No: 000295

U
S
TSubject: CHANGE OF CANOPY AFT
HINGE ATTACHMENT IN
EAGLE II AIRCRAFT 904 AND
915 CONSTRUCTION KITS

ENGINEERING SKETCH X-90136

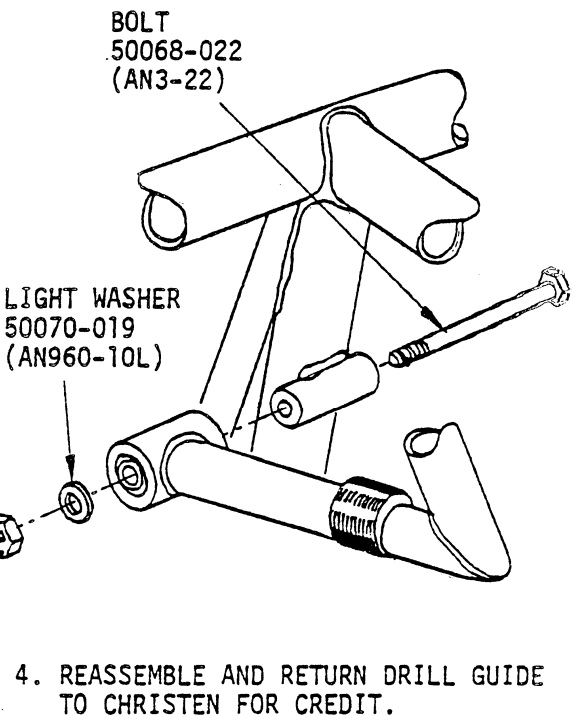
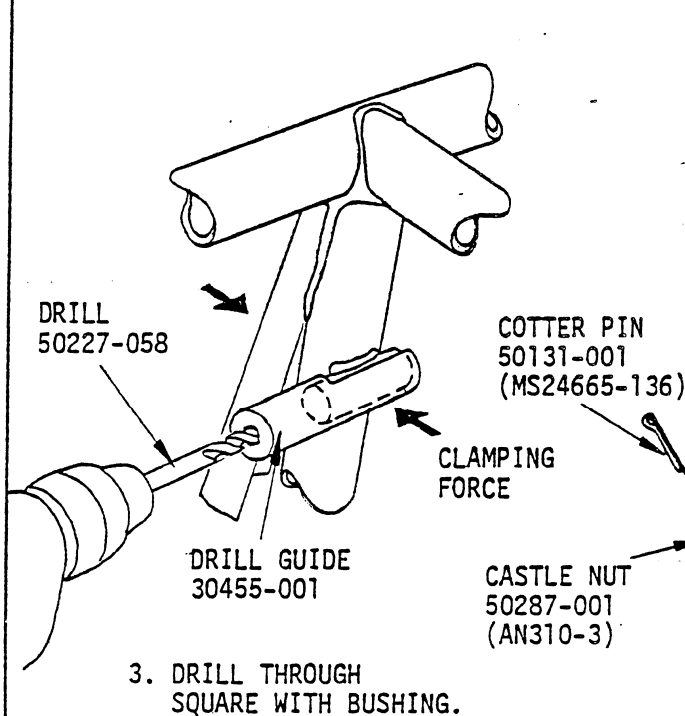
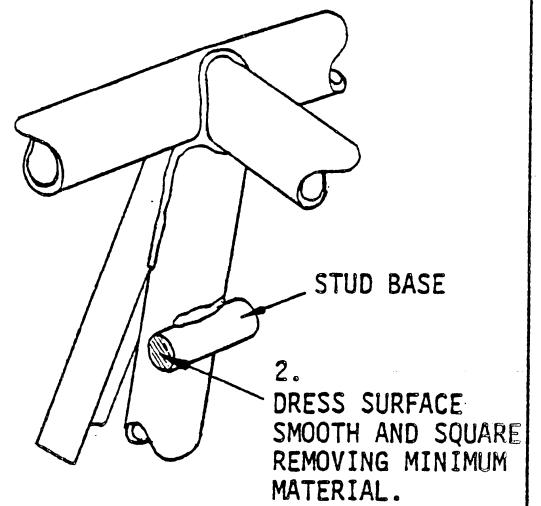
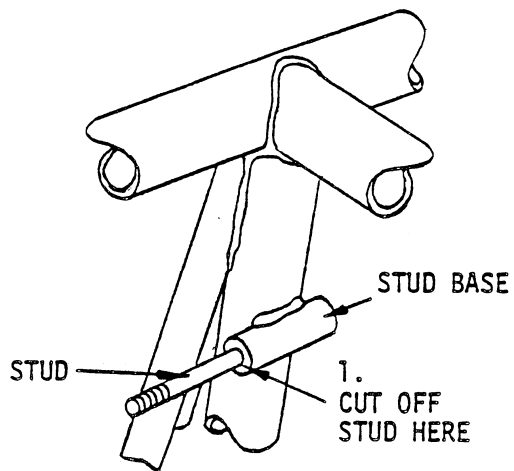
Eagle II aircraft fuselage structures manufactured prior to January 1983 used a hinge support stud, located behind the right rear seat armrest, which supported the rear hinge of the canopy system. Several aircraft have experienced failure of this stud.

Although flight safety is not affected by failure of the stud, the rear hinge attachment has been redesigned for increased strength and serviceability. All 904 Fuselage Structure Kits and 915 Canopy Kits delivered after January 1983 have been supplied with the redesigned hinge attachment.

The fuselage modification procedure for the new hinge attachment consists of trimming off the original stud and drilling through the stud base to form a support bushing through which a new hinge support bolt can be mounted. A special drill guide and drill are required as listed below. (It is essential that a properly sharpened drill be used to ensure hole straightness, location, and angle.)

Modification of the canopy system consists of simply adding a bolt, castle nut and cotter pin to replace the original thin nut and support stud.

For modification, refer to attached Engineering Sketch X-90136 and proceed as follows. If the 915 Kit manual is available, also refer to Step D-2:

4. With a fine-blade hacksaw, carefully cut off the canopy hinge support stud at its shoulder without removing any material from the shoulder. File away any remaining stud portion smooth and flush with the shoulder, removing a minimum of material from the shoulder.

5. Slide the 30455-001 drill guide over the stud base toward the rear of the fuselage until the internal shoulder of the guide is against the shoulder of the stud base. Clamp the guide in position with a small C-clamp.

6. Using the drill guide, carefully drill through the center of the stud base with the 50227-058 (3/16" DIA) drill. To ensure a straight and properly aligned hole, hold the drill without lateral or twisting forces on the sides of the drill guide. Apply and release drilling force alternately to clear drill cuttings. Use a lubricating or cutting oil on the drill while drilling.

7. If the canopy was installed previously, reinstall it using the 50068-022 bolt, 50070-019 washer, and 50287-001 castle nut for the rear hinge attachment. Tighten the nut securely to seat all bearing parts, then loosen the nut slightly to allow free rotary bearing movement with

8. Secure the castle nut in its adjusted position with the 50131-001 cotter pin. Clinch the prongs of the cotter pin if the aircraft has been completed (through 923 Kit), or spread the prongs only slightly to keep the pin in position, but to allow removal later during remaining construction.
9. Reinstall all rear seat and canopy components as appropriate.
